Remarks/Arguments

Appl. No. 10/084,629 Reply to Office Action dated April 1st, 2003 **Annotated sheet showing changes**

FIG. 2

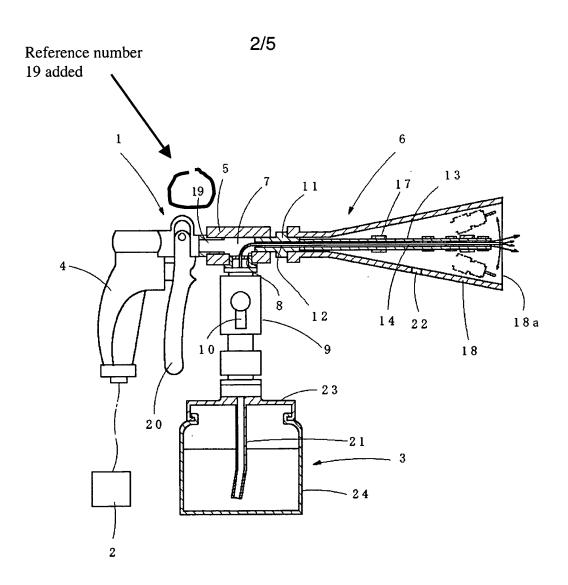
The Examiner has objected to the drawings for being non-compliant with 37 CFR §1.184(p)(5) for failing to include reference number 19, which was disclosed on page 13, line 21. Applicant has amended the drawings for clarification. Applicant submits herewith as an attachment replacement sheets for Figure 2 and Figure 4. These sheets will replace the original sheets for Figure 2 and Figure 4. Also submitted herewith as an attachment are annotated sheets indicating to the Examiner what changes have been made. Applicant believes the drawings to now be in compliance with 37 CFR §1.184(p)(5) and respectfully requests that the Examiner's objection to the drawings be withdrawn.
